Burlington Design Advisory Board

DESIGN ADVISORY BOARD Tuesday, May 12, 2015 at 3:00 PM Conference Room 12, City Hall, Burlington, VT

To: The Design Advisory Board
From: Mary O'Neil, AICP, Senior Planner
RE: ZP 15-0895CA 124 Staniford Road
Date: May 12, 2015

RE: ZP 15-1000CA; 170 & 180 Carrigan Drive (formerly identified as 10 University Place, UVM undergraduate student housing)

Front Porch

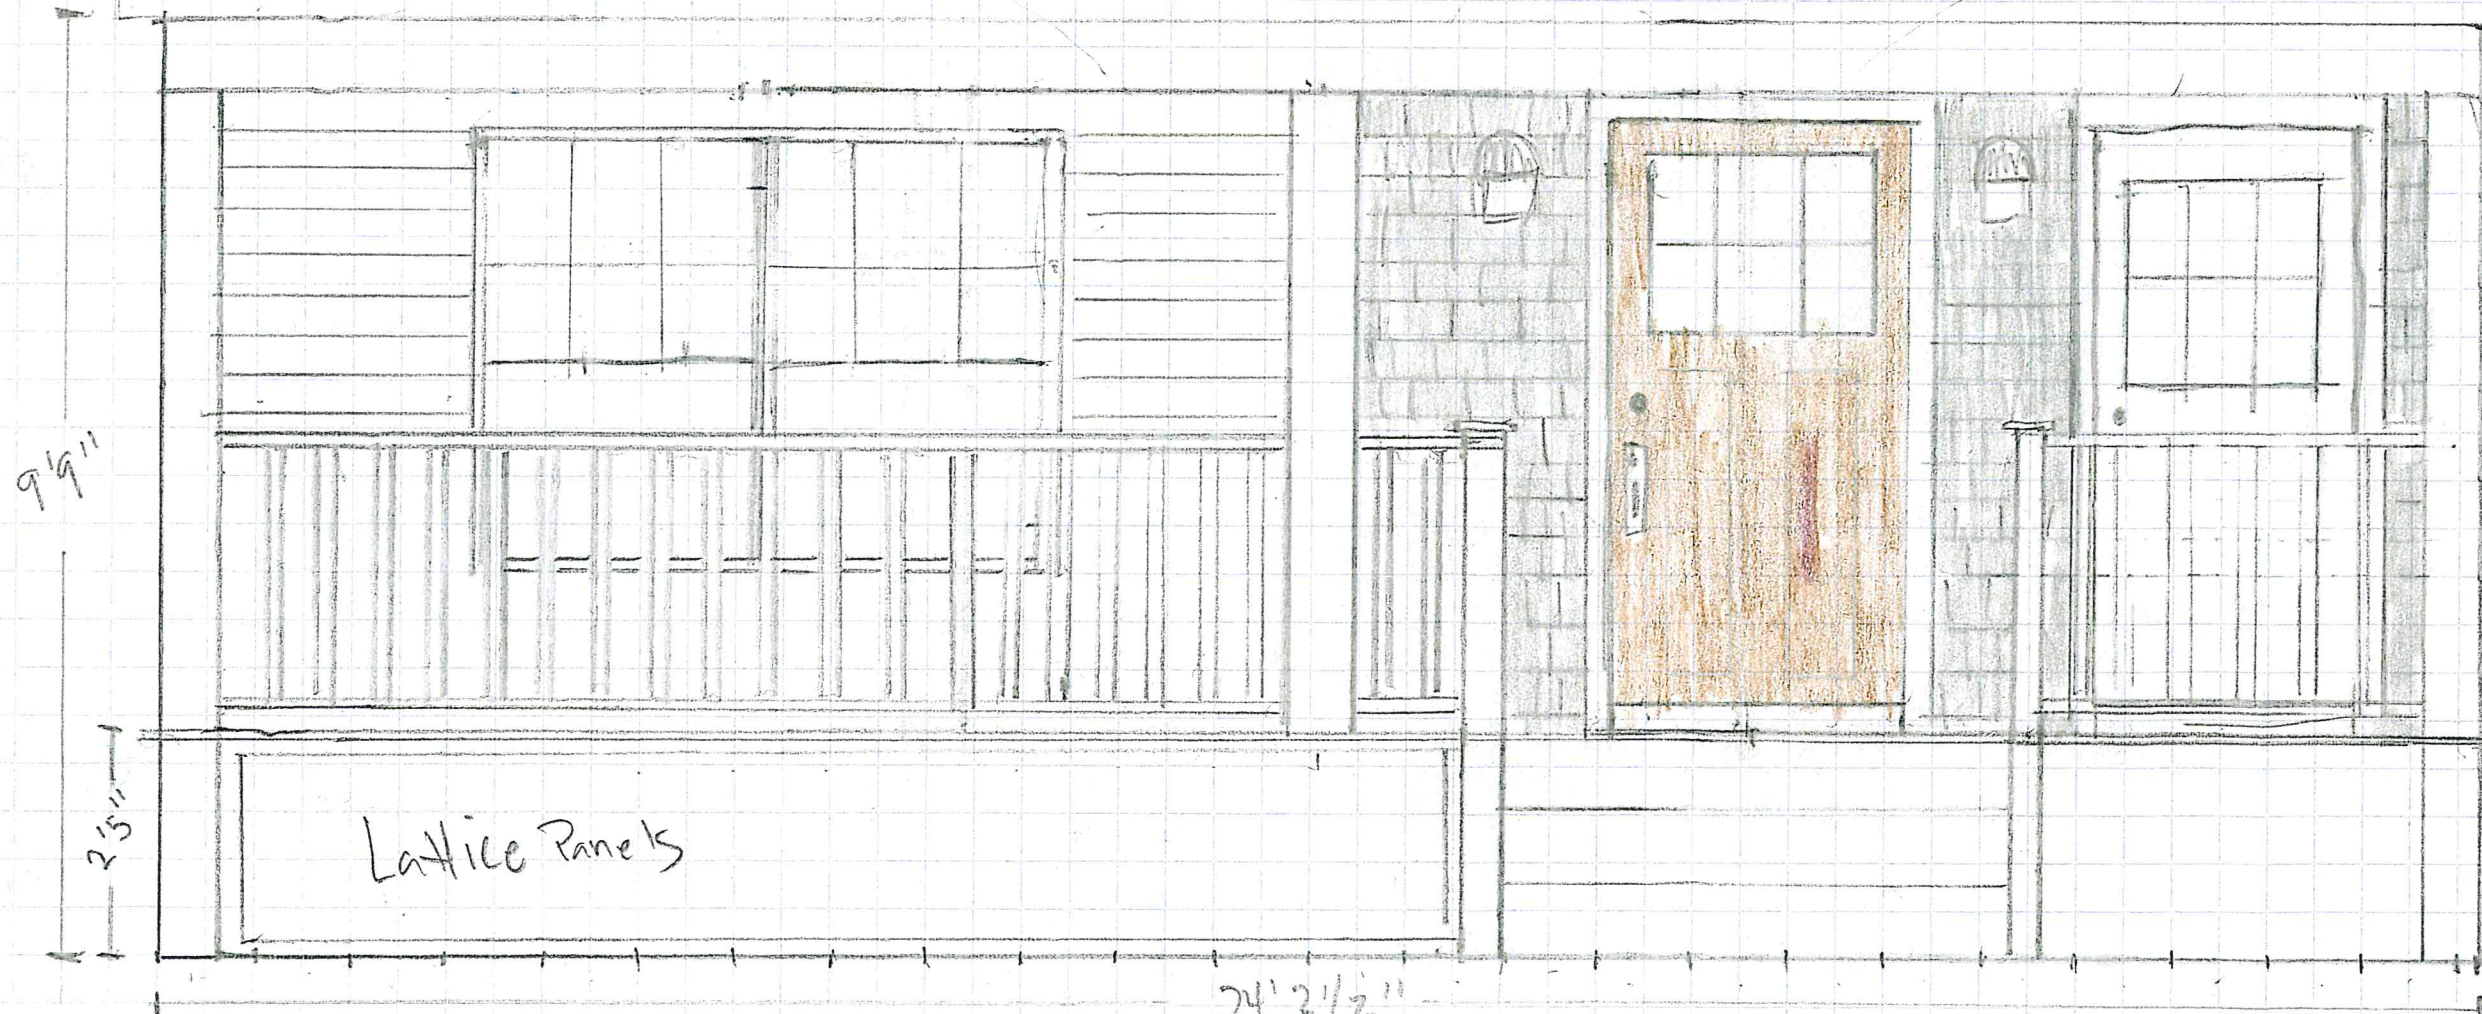
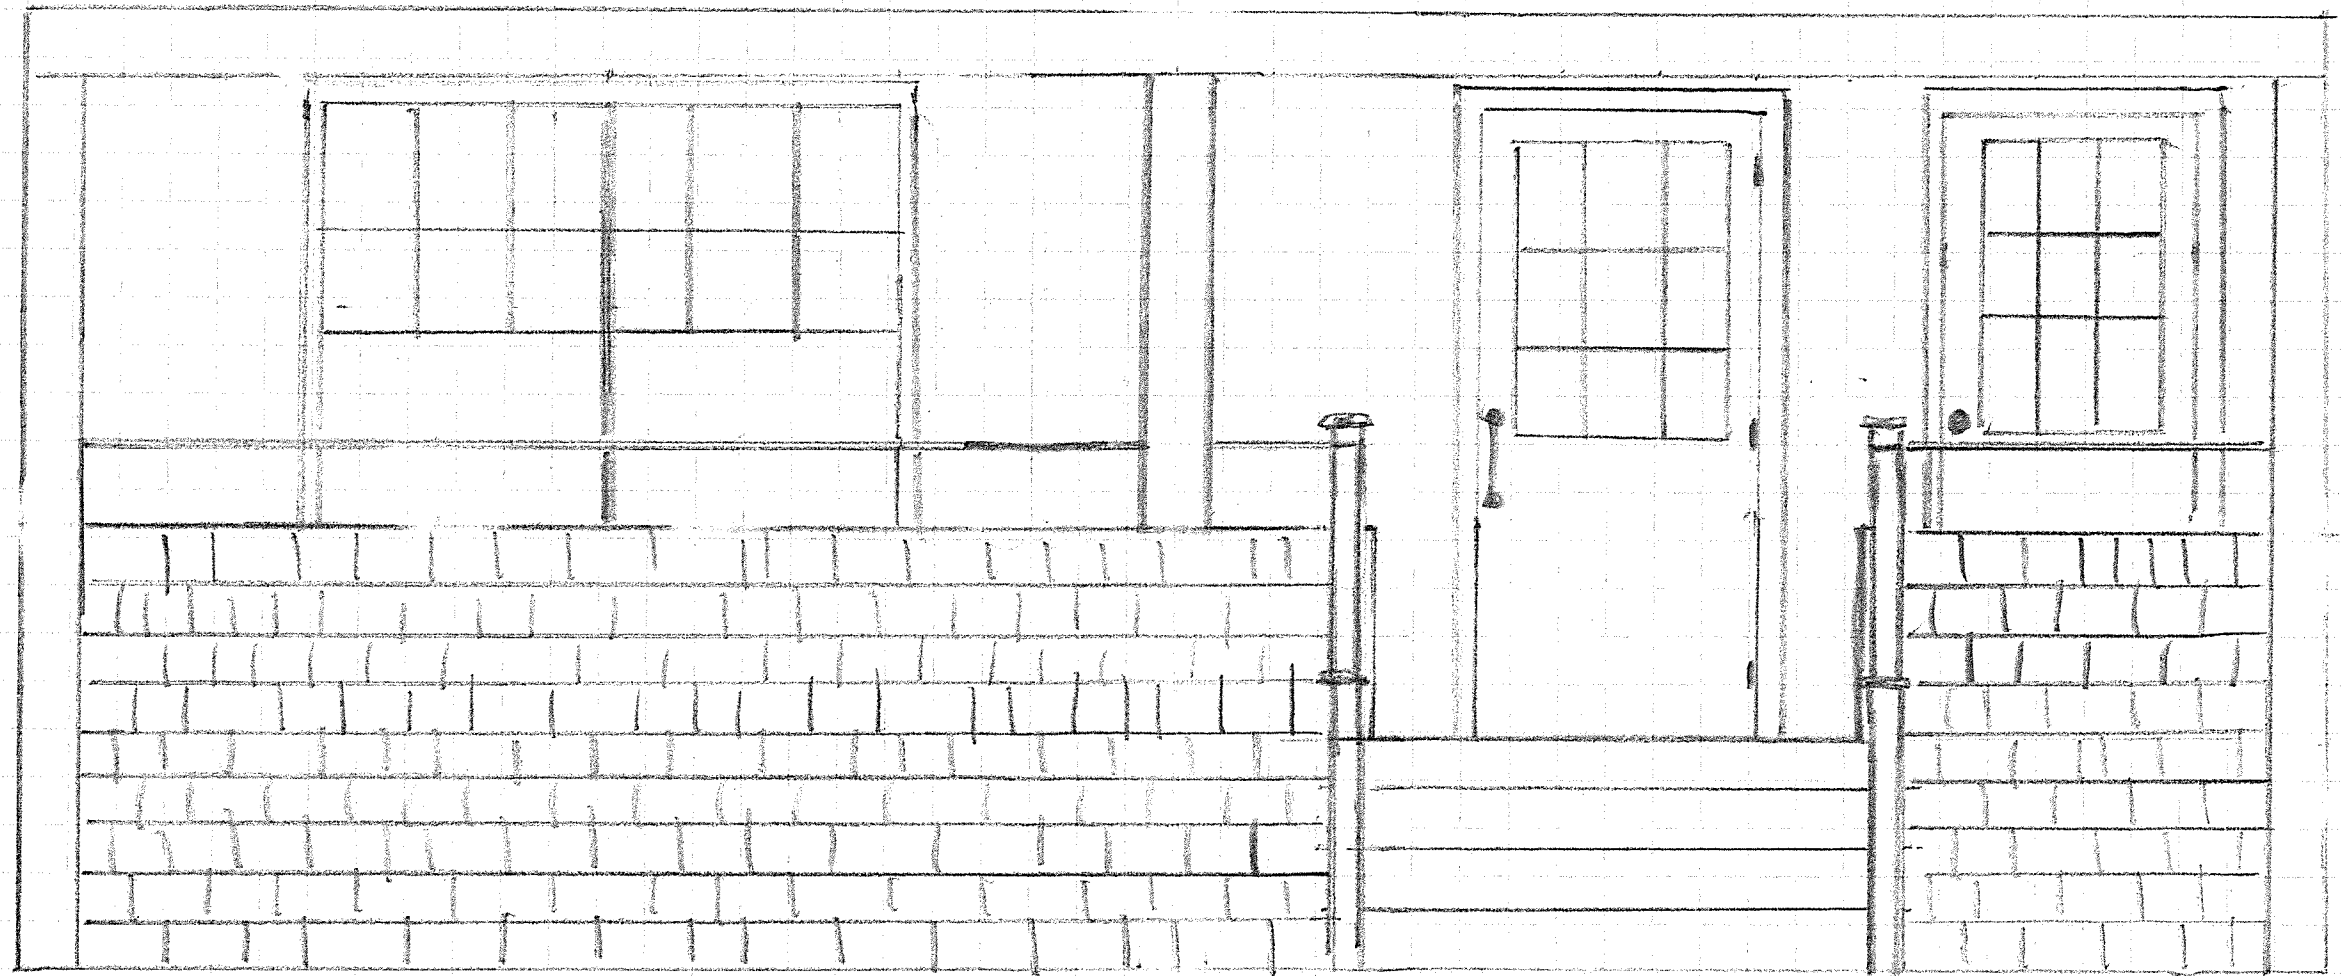
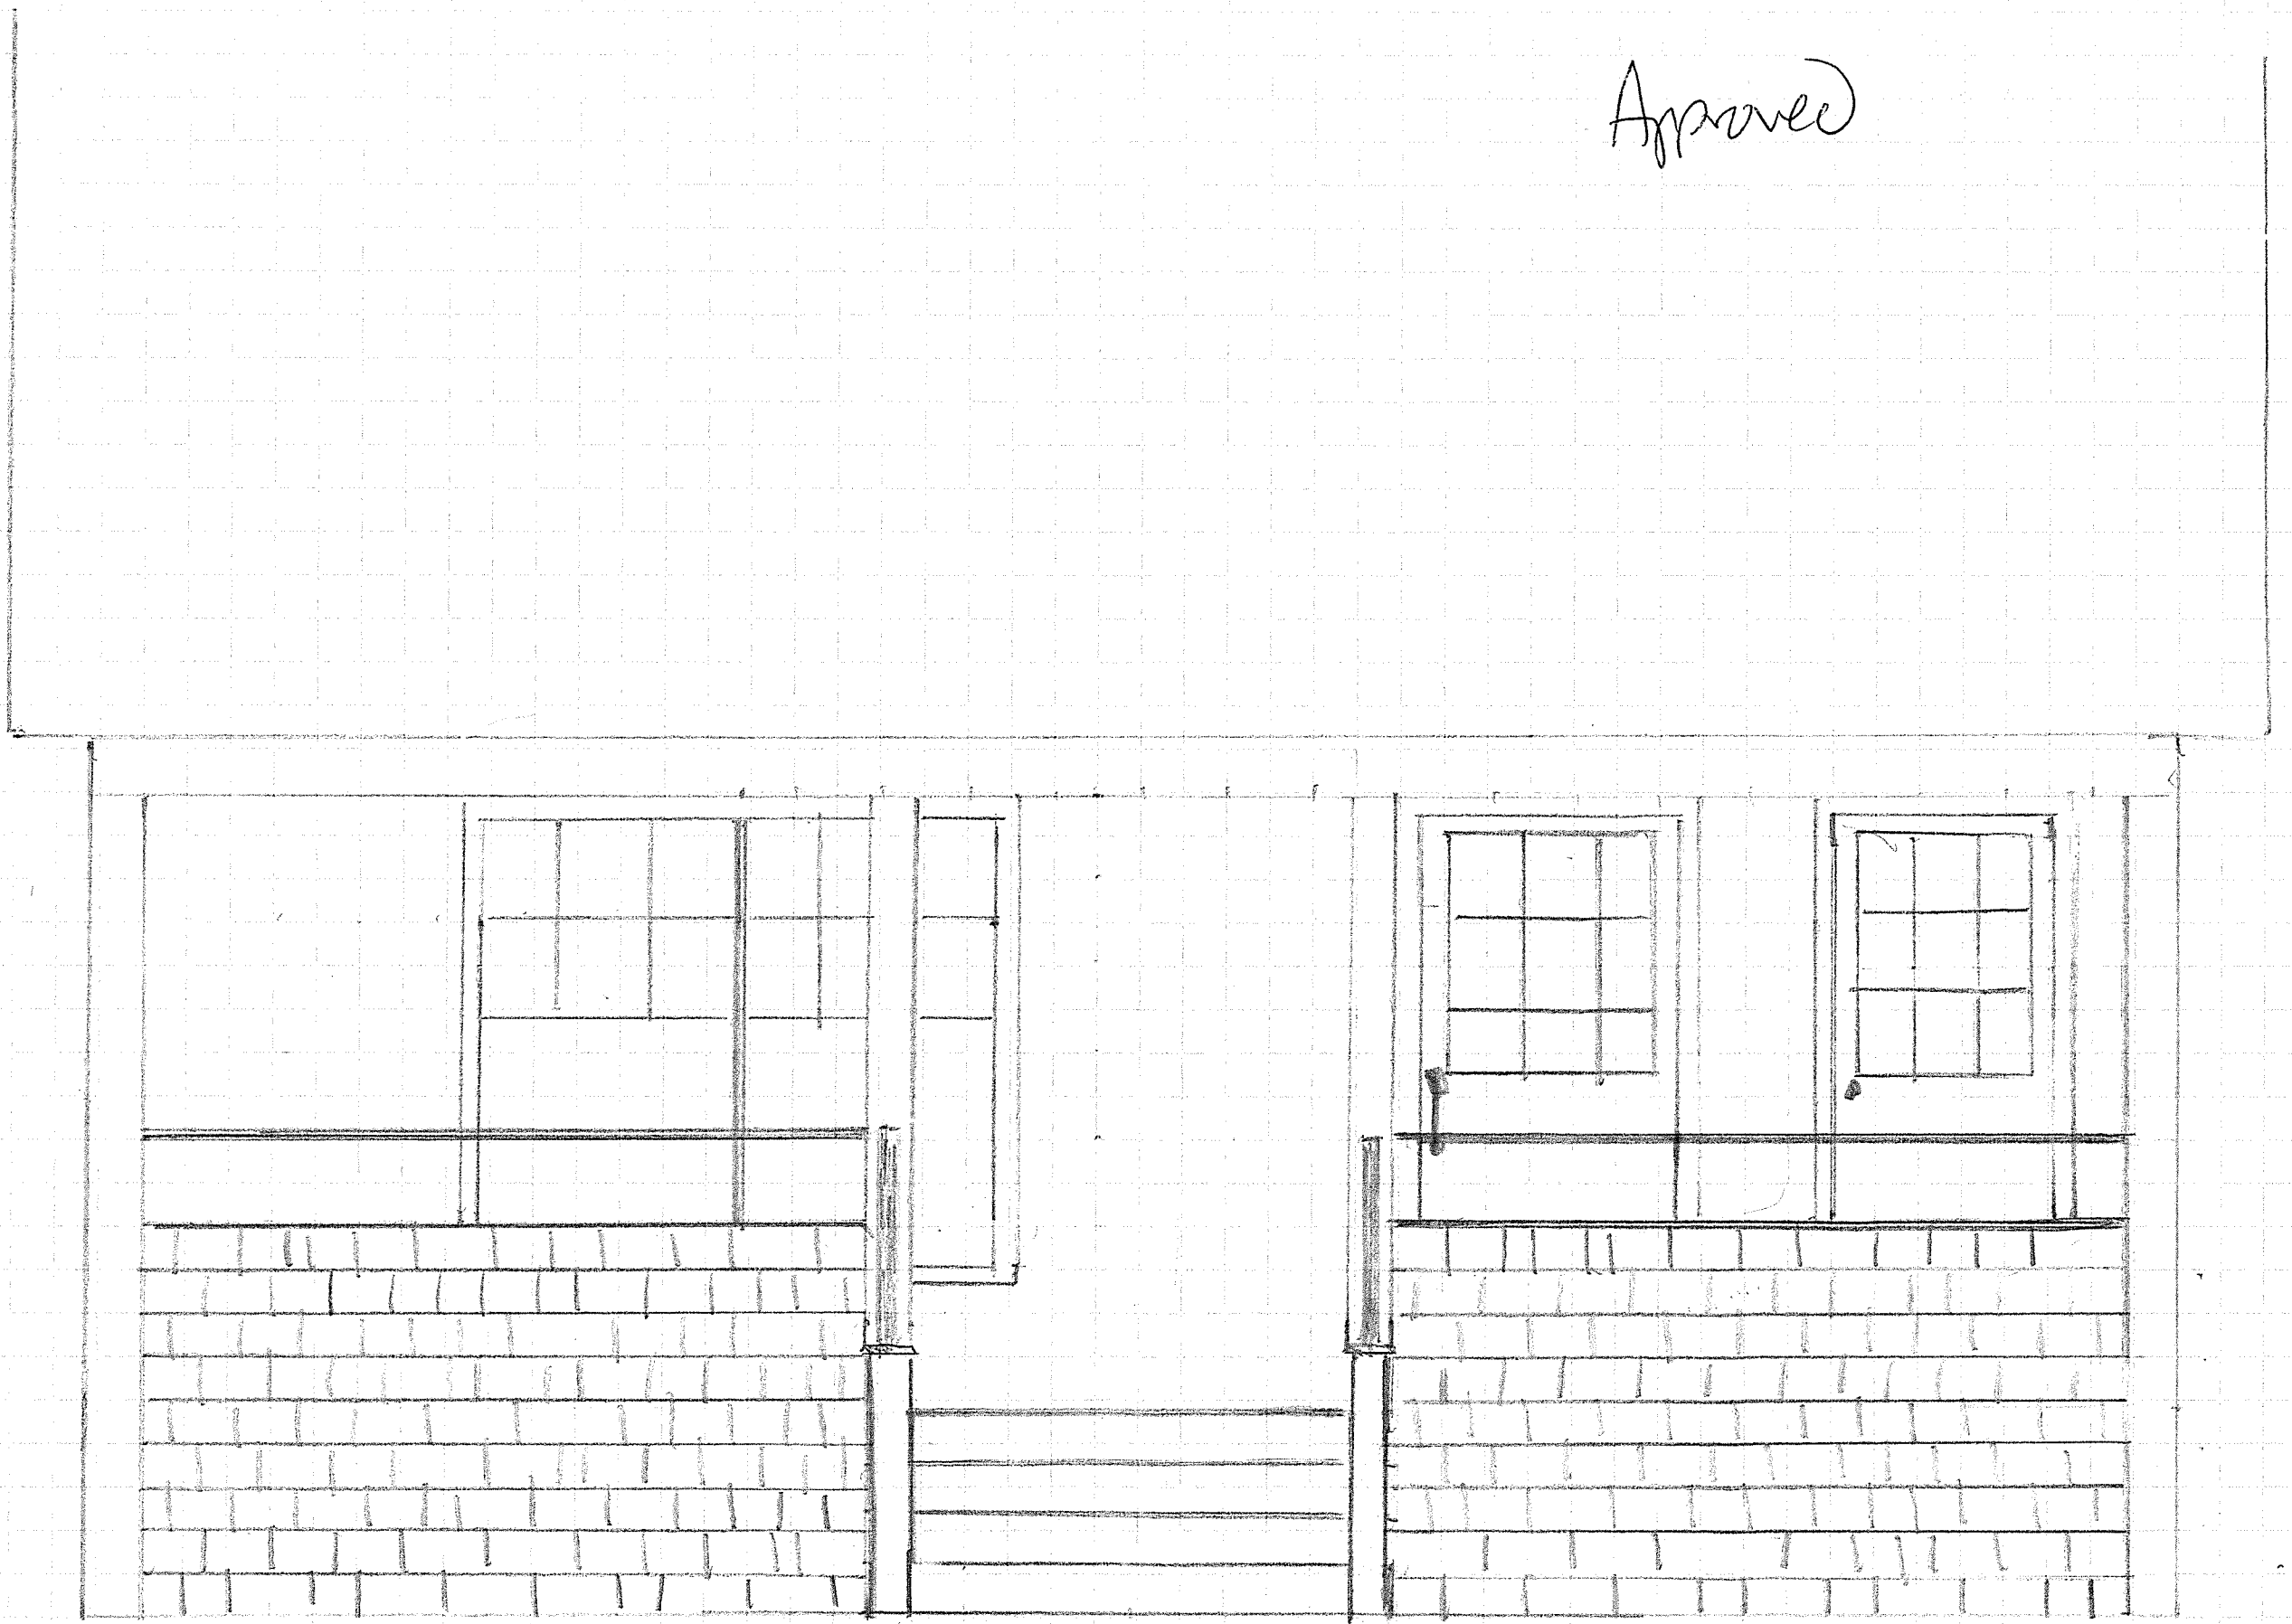
Approved with
conditions by
Design Advisory
Board. See
Conditions of
approval:

1. Center posts to
maintained
2. Center stairs
not more than
6' wide.
3. Shake porch
maintained, but
guard rail if h

proposed

need to see DAB again -

Motion by Matt Bushey – move to approve relocating stairs in front of the door as shown on applicant sketch, with condition that another post added. Posts are to be centered on / flanking stairs in such a way that rails align with posts. Applicant will submit a revised plan illustrating the recommended changes.
